WCAP-17573-NP-A
Revision 1

Westinghouse SMR Small Break LOCA Phenomena Identification and Ranking Table

SUBJECT: WESTINGHOUSE ELECTRIC COMPANY'S FINAL TOPICAL REPORT SAFETY EVALUATION FOR WCAP-17573, REVISION 1, "WESTINGHOUSE SMALL MODULAR REACTOR SMALL BREAK LOSS OF COOLANT ACCIDENT PHENOMENA IDENTIFICATION AND RANKING TABLE"

Figure 1-2 Reactor Vessel Regions

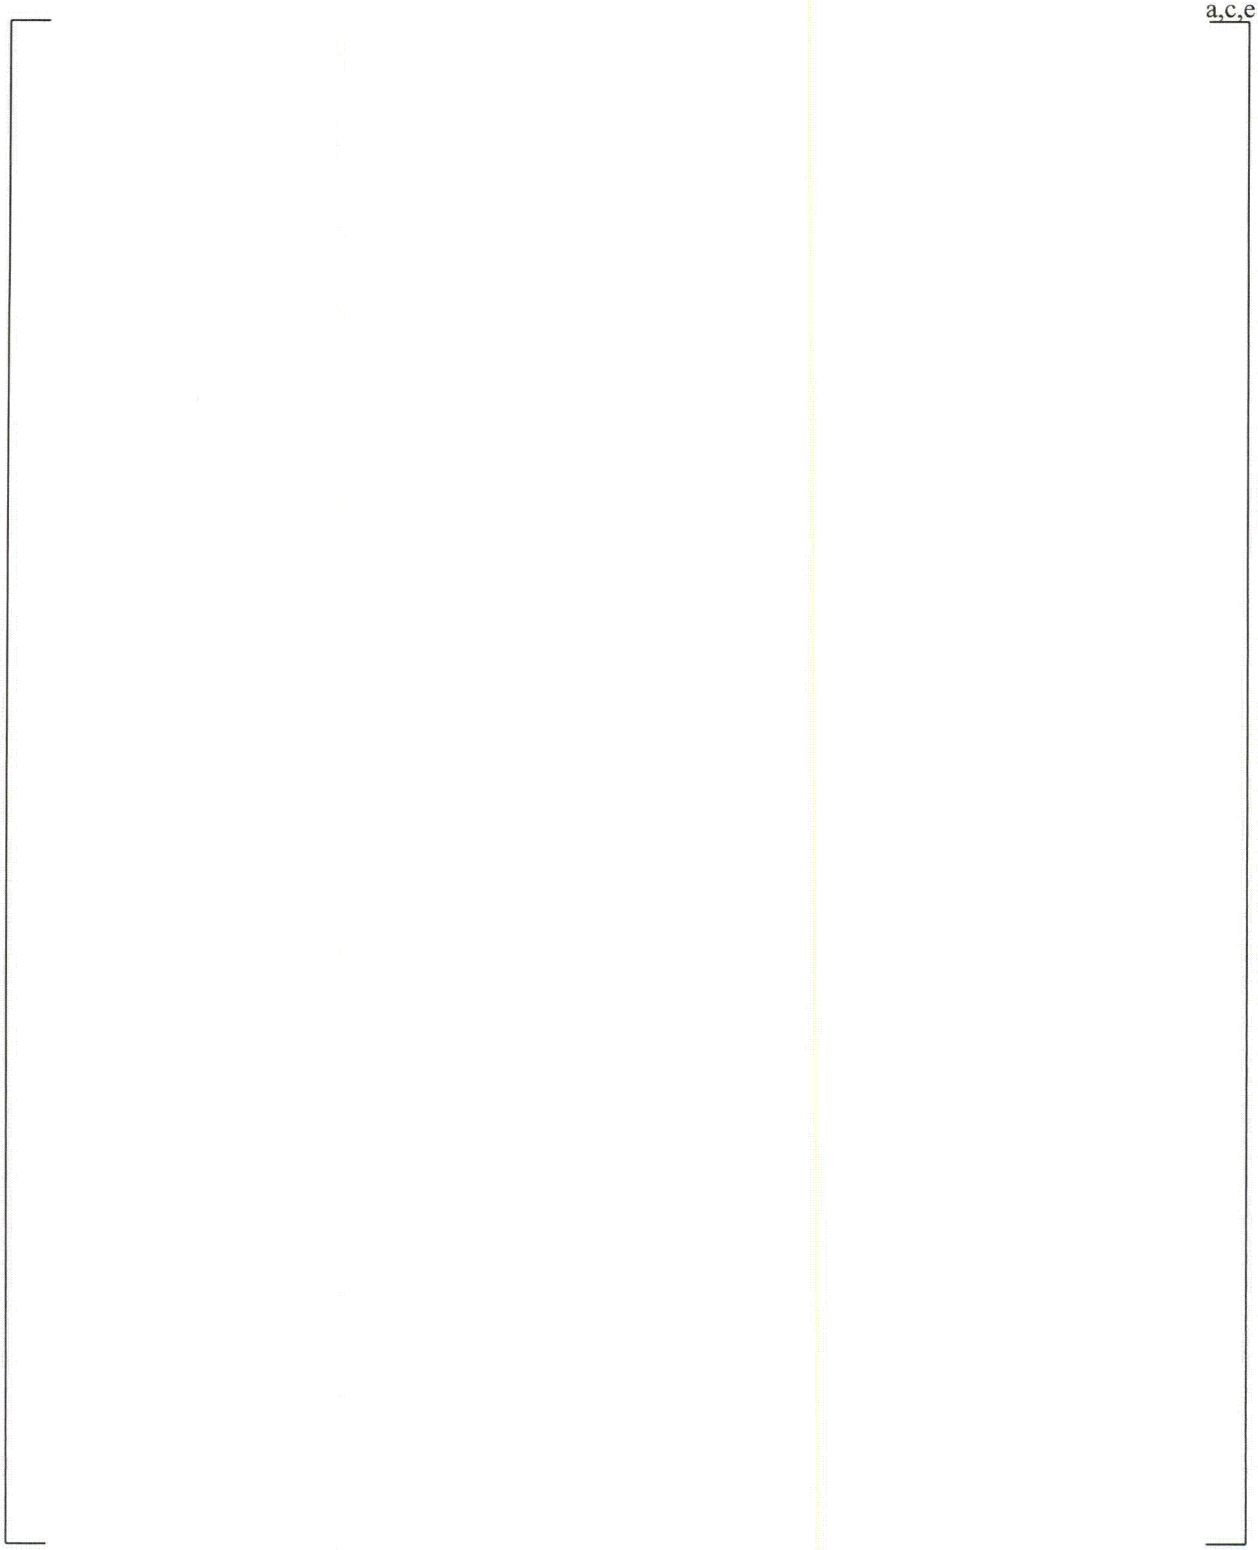
Please make changes, if necessary, to Tables 1-2 and 1-3 and Figure 1-2 based on the latest design information.

The changes to Tables 1-2 and 1-3 and Figure 1-2 are provided in response to RAI-TR-SBLOCA-PIRT-103.

WCAP-17573-P Tables 1-2 and 1-3 and Figure 1-2. These changes are provided in the response to RAI-TR-SBLOCA-PIRT-103-P which contains a table of the changes and recommended mark-ups of WCAP-17573-P.
